Product Change Notice (PCN)

PCN Number: PCN-65280402R-01

- VMS-300-x-y (x=12, 15, 24, 36, 48, 0512 or 1224; y=blank, CF or CFS) series
- VMS-300-Dx-y (x=12, 15, 24, 36, 48, 0512 or 1224; y=blank, CF or CFS) series

For U & CF type - Current terminal block-

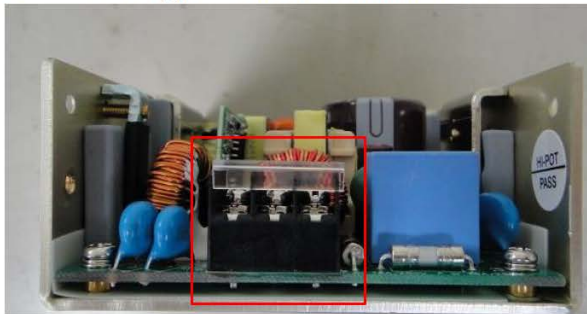
Description of Change: IEC 60601-1: 2005+ A1, EN60601-1: 2006+A11+A1+A12 requires input connector to have European approval (TUV, VDE or EN/EC etc.). The new connector, which meets European approval, does not have the plastic cover. See updates highlighted within Red squares in the images below:

New terminal block-
